# RIVERBEND CROSSING FILING NO. 1

## STREETS, STORM & STRIPING

### CONSTRUCTION PLANS

PCD File No. SF-18-044  
Unresolved.

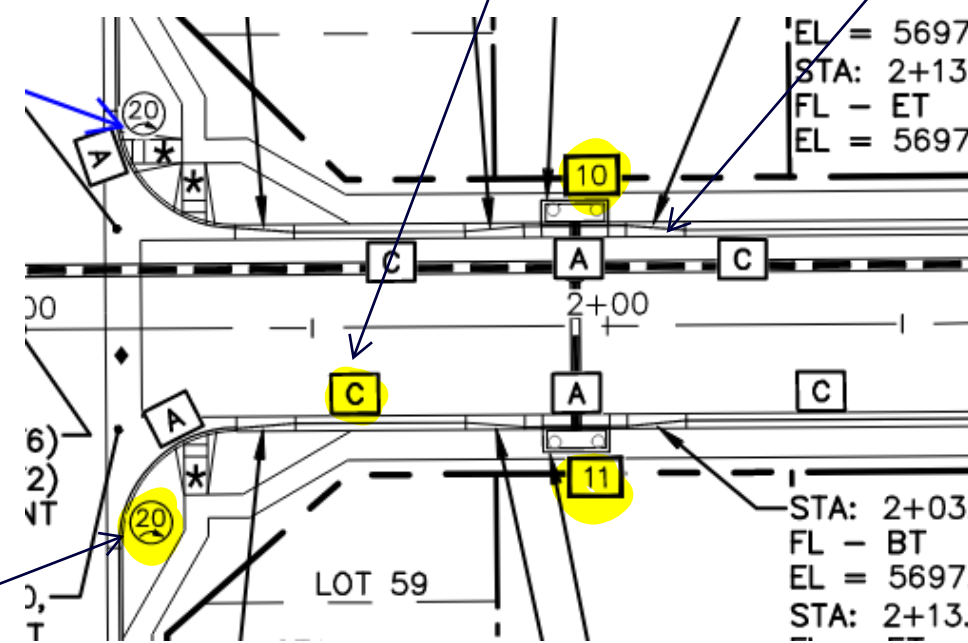
Add symbols highlighted in yellow to the legend.

RIVERBEND CROSSING  
FILING NO. 1  
TAK LANE  
STREET IMPROVEMENT PLAN

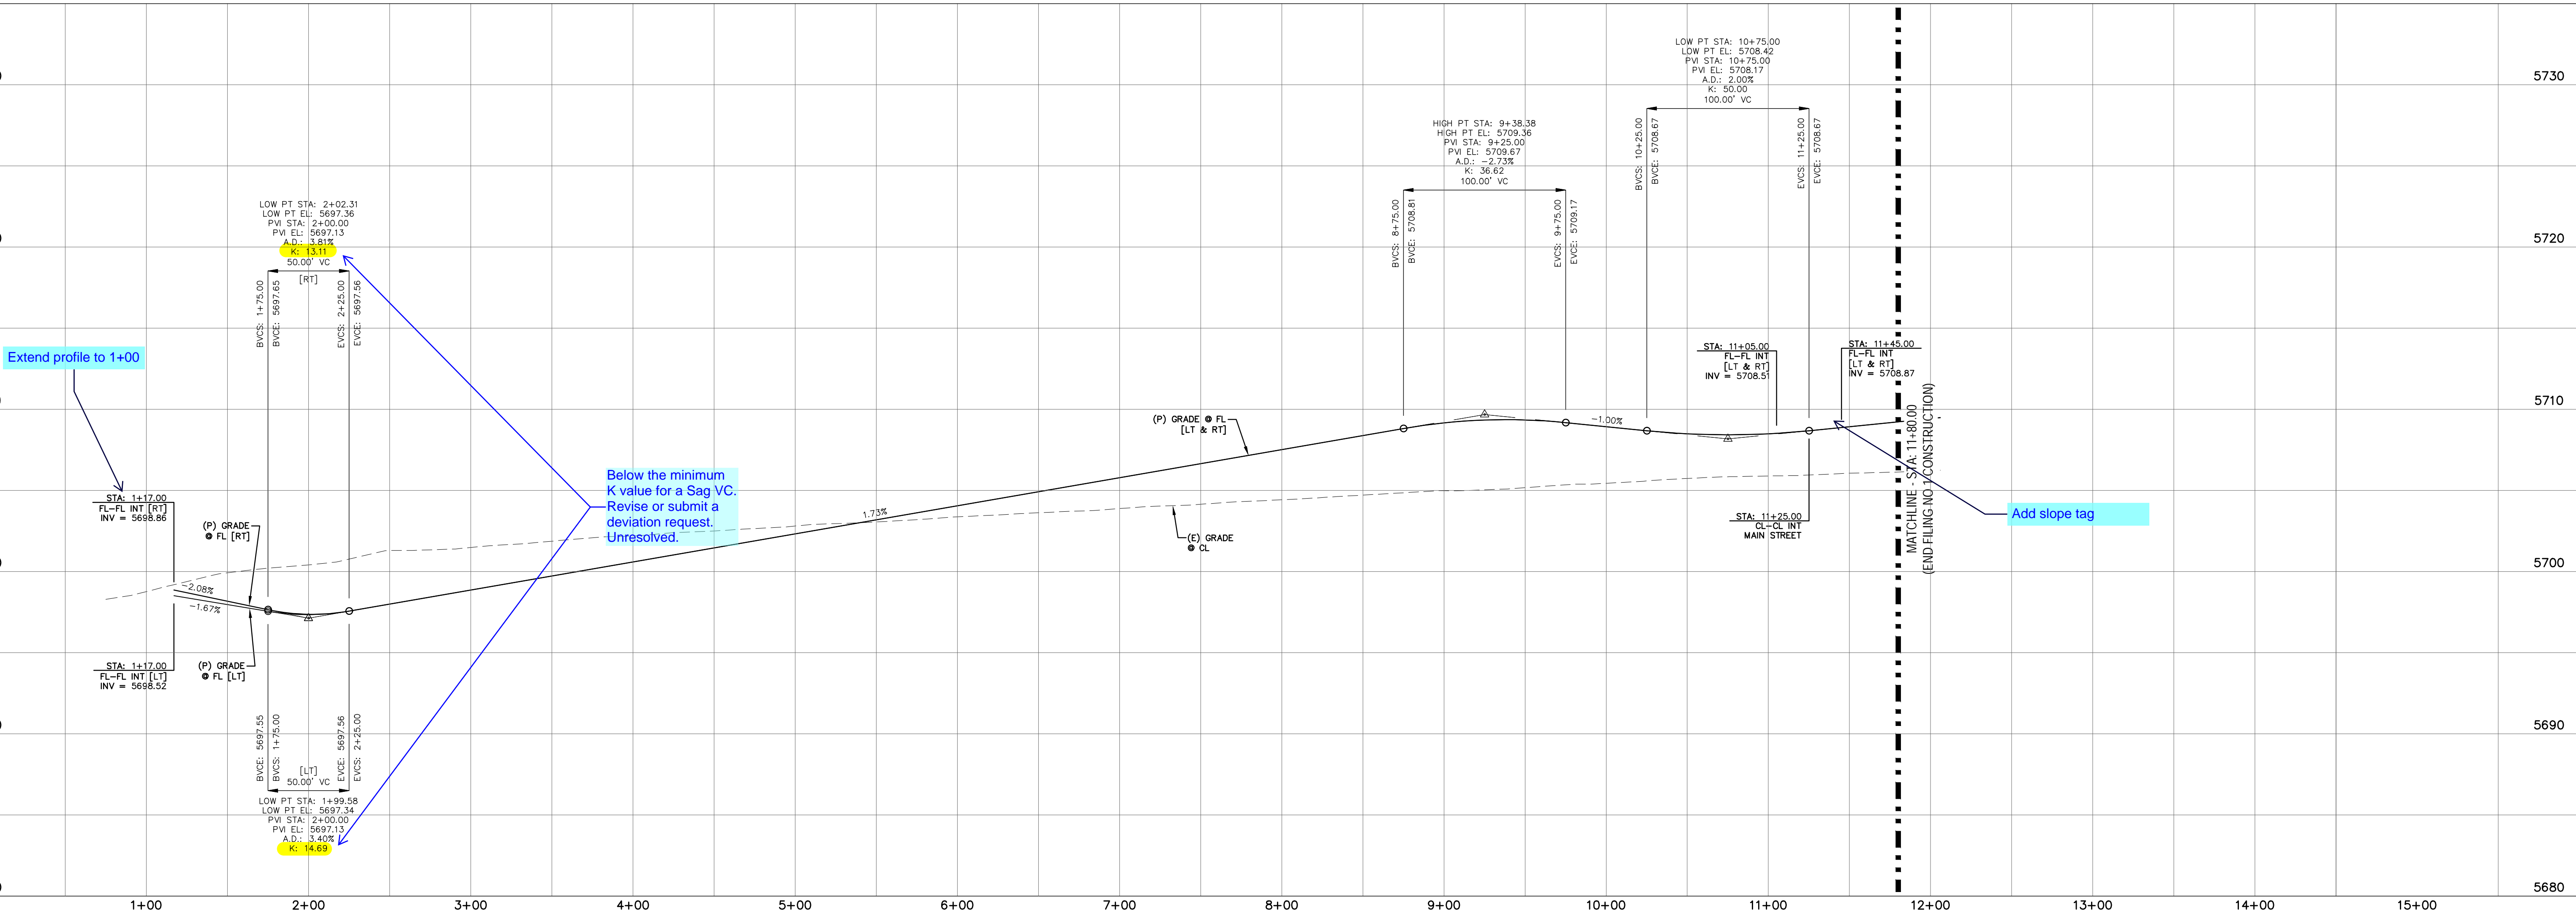
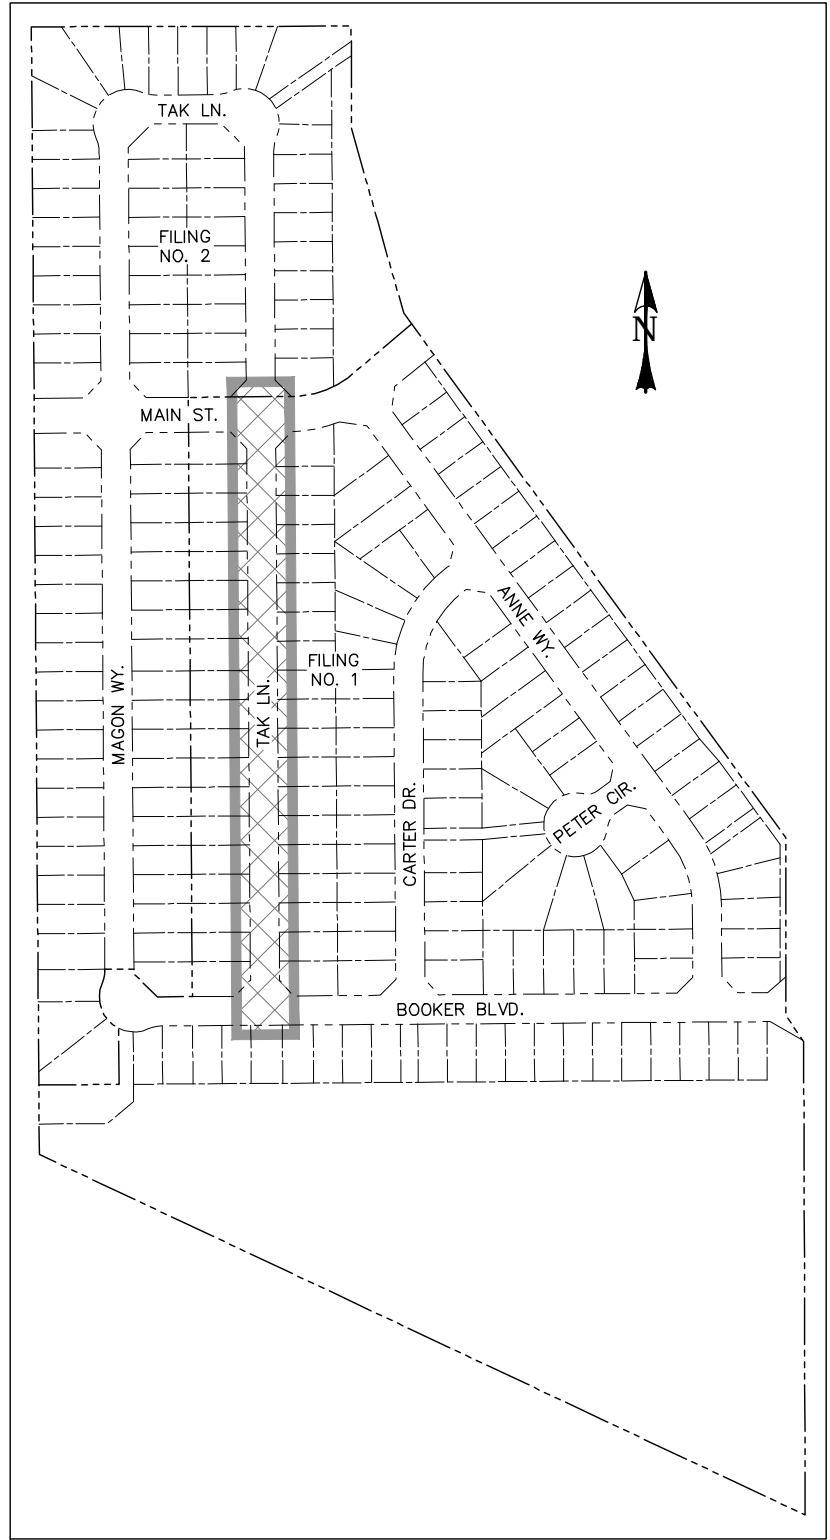
Road profile must be flatter at the intersections where ADA crossings are provided in order to meet the ADA criteria for cross slopes (2% max). Typ. all. Unresolved.

Move label so it's not blocking the ramp, typ. all. Unresolved.

Provide a legend symbol for "C". Unresolved.

Provide road classifications of all roads. Unresolved.

Provide curve data for the curb returns. Unresolved.

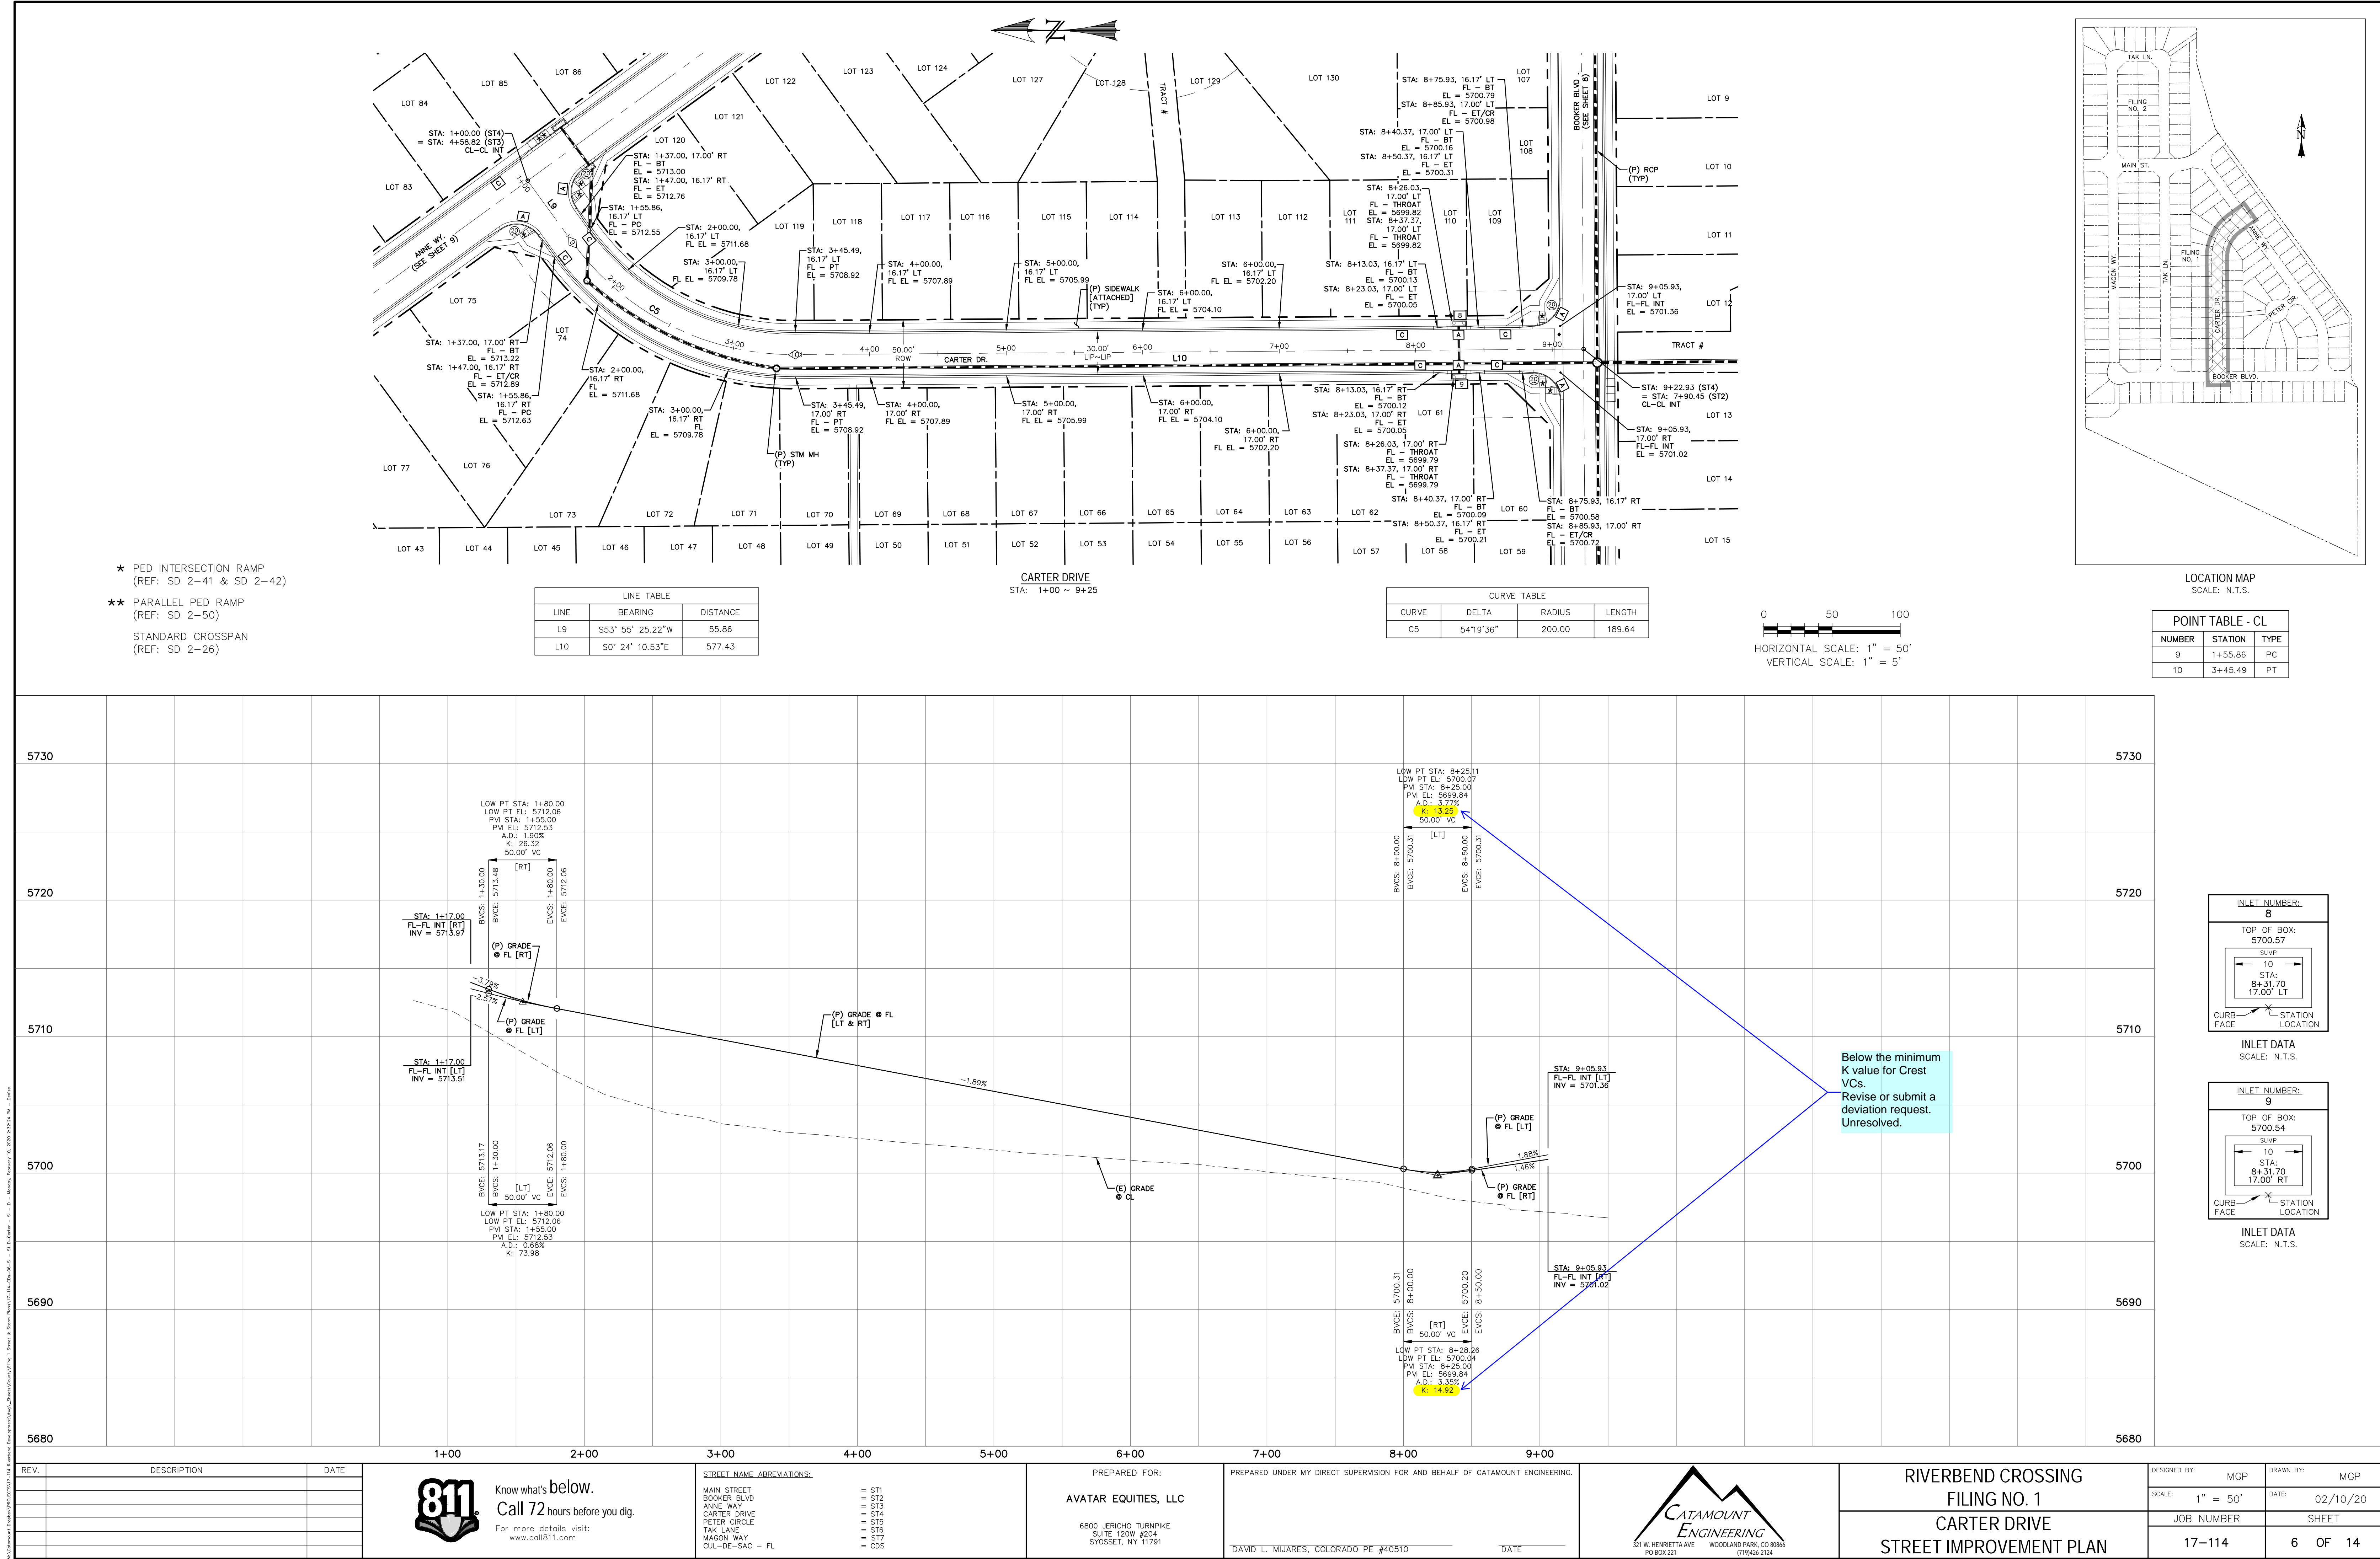
Adjust plan view to show the full extent of the storm sewer shown on the profile view.

RIVERBEND CROSSING  
FILING NO. 1  
STORM SEWER  
PLAN & PROFILE

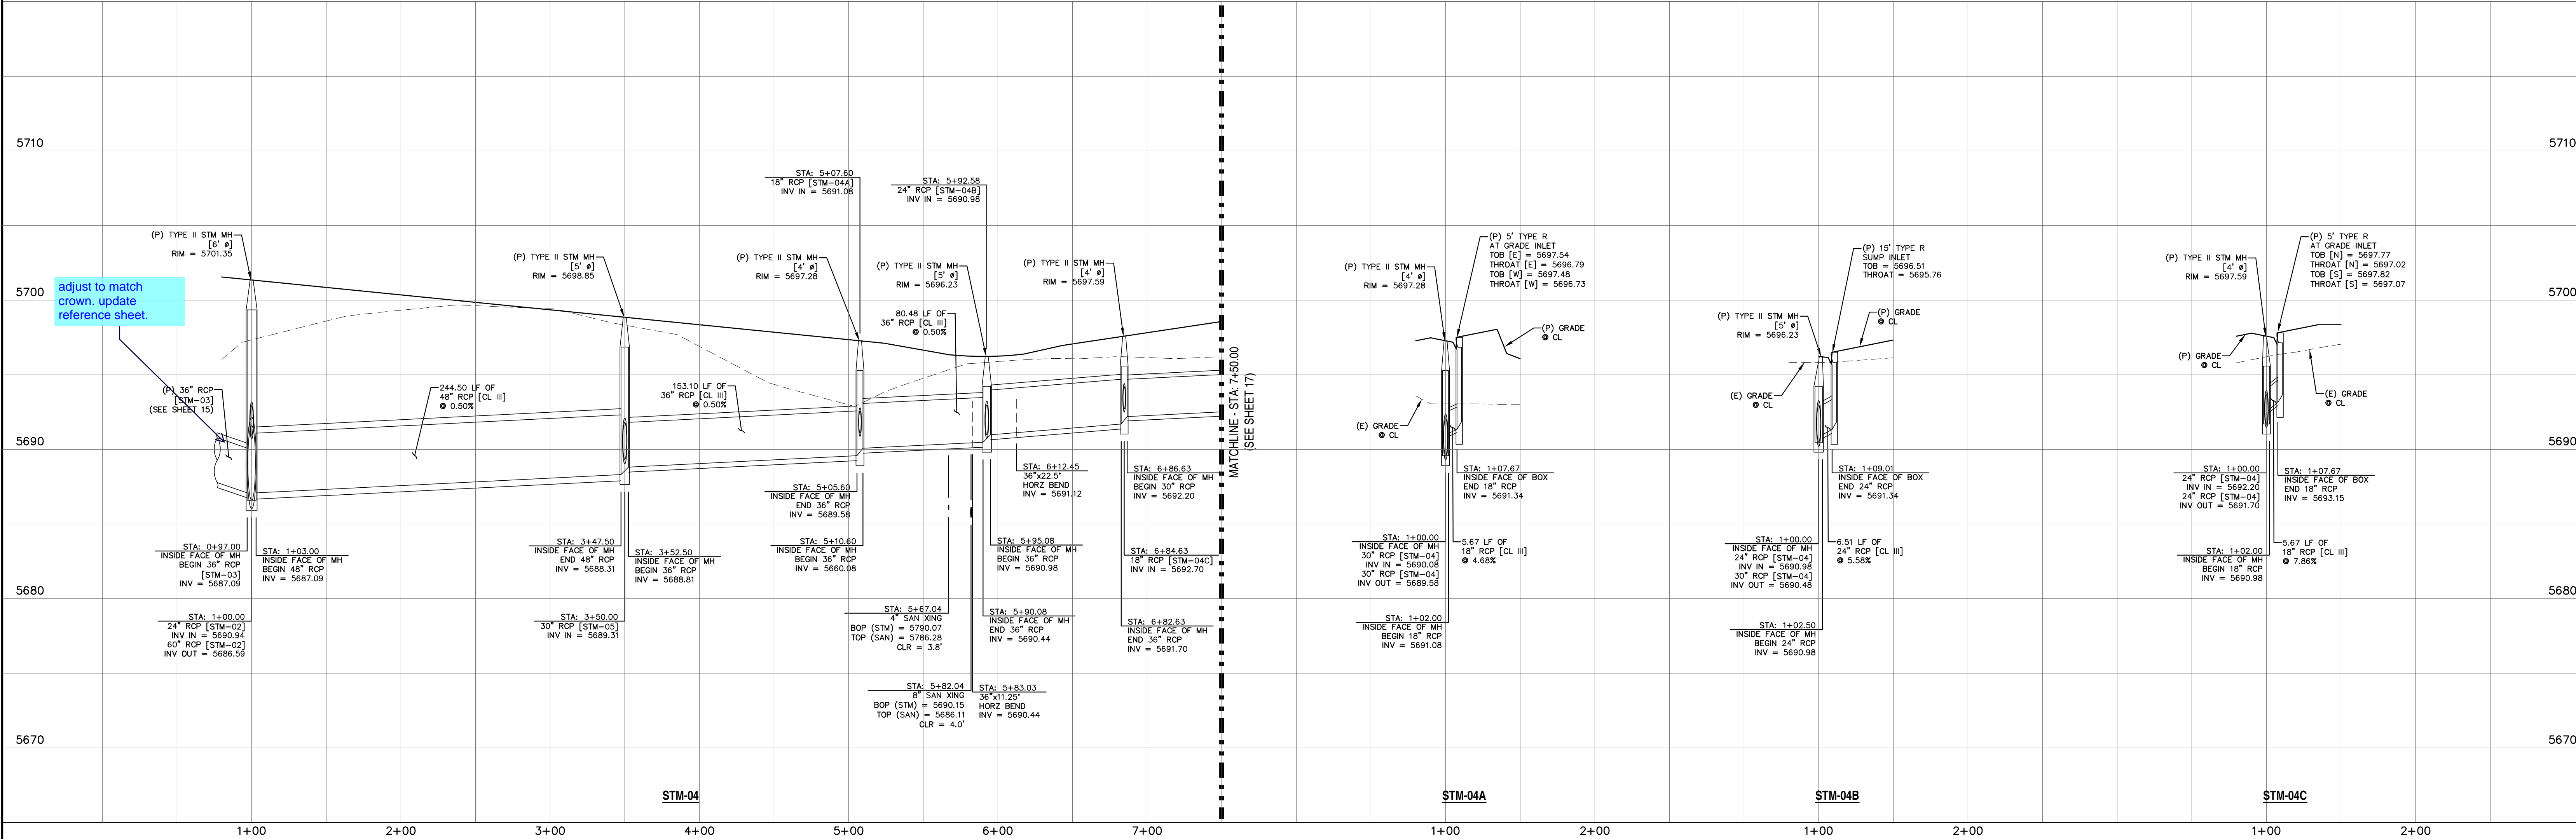
Provide construction plans for the private storm pipe/area drain along the rear lot lines of Basin B17.

Revise. Drainage report notes 20' inlet. Based on the inlet location, Filing 2 Lot 1 does not have a viable inlet location. Revise the design.
